# Product Change Notification

## TE Connectivity

**Product Change Notification:** E-19-015991

2, 3, 6pos MCON 1.2 - LL Connector, Sealed.

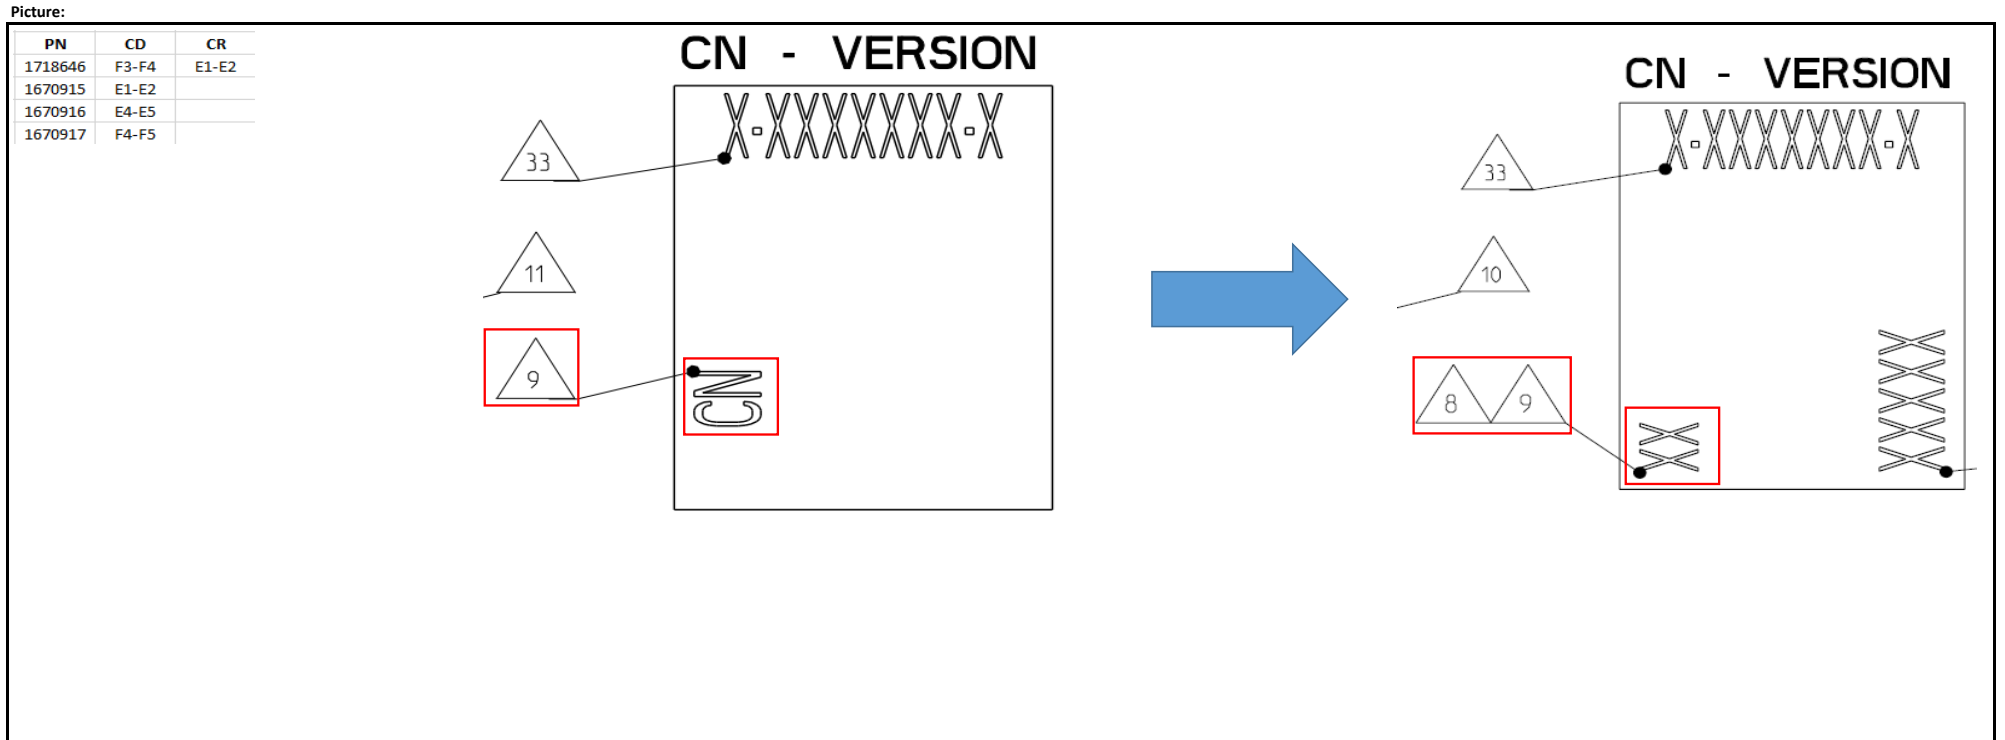
The drawings for the listed part numbers have been modified for clarification for the details within the Laser-Print. For more information please refer to the enclosed spreadsheet. There is no physical change on the parts. Only the drawings have been adapted.

X	Potential Impact for Customer	X	Product Type	X	Change Type	X	Kind of Change	X	Change Feature	Remark / Free text
		x	Connector	x	Drawing	x	Drawing Change			Laser-print updated with additional information on the location and assembly line segment identification for CN manufacturing.
